**NEBRASKA ARMY NATIONAL GUARD
LINCOLN COMPLEX BUILDING 1600
ROOF REPLACEMENT PROJECT**

PROJECT NO. 31030377

A D D E N D U M N O. 1

RTU CURB CAP DETAIL

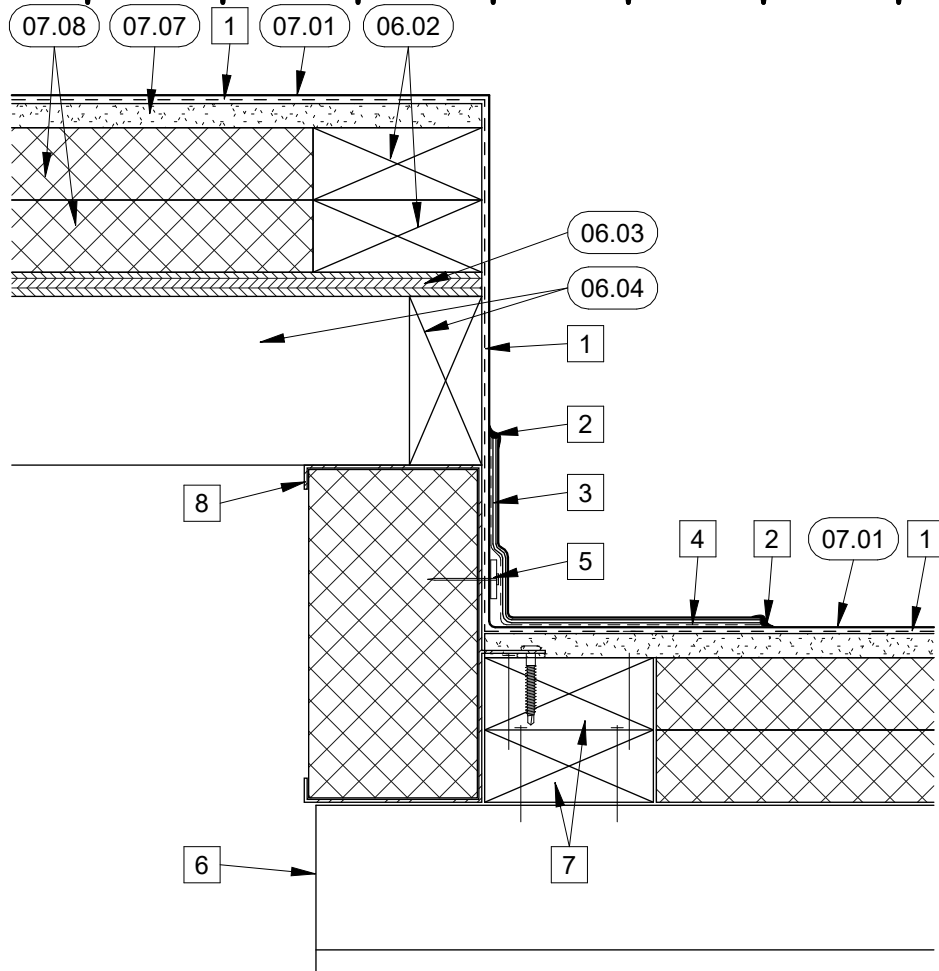
4. Sheet A199, Detail D8, Curb Flashing Detail – Change to RTU Curb Cap Detail, see attachment #4.
5. Sheet MEP 191, Roof ME Plan High Roof Area B – New

- 06.02 (2) 2x4 EDGE BLOCKING.
- 06.03 1/2" OSB.
- 06.04 2x4 FRAME WITH 2x4 SPANNING 16" O.C. SECURED TO CURB.
- 07.01 90 MIL EPDM ROOF MEMBRANE.
- 07.07 1/2" COVERBOARD.
- 07.08 1 1/2" POLYISO INSULATION.

- 1. BONDING ADHESIVE.
- 2. CONTINUOUS BEAD OF LAP SEALANT.
- 3. 9" FLASHING SET IN SEALANT.
- 4. FLASHING SEALANT.
- 5. FASTENING STRIP (BAR) AND FASTENERS.
- 6. ROOF STRUCTURE / DECK.
- 7. 2x4 WOOD BLOCKING CONT. SECURE TO ROOF DECK / BLOCKING.
- 8. EXISTING CURB.

- 1. PROVIDE SEALANT OVER FASTENER HEADS AND ALONG ENTIRE EDGE OF CURB FLANGE.
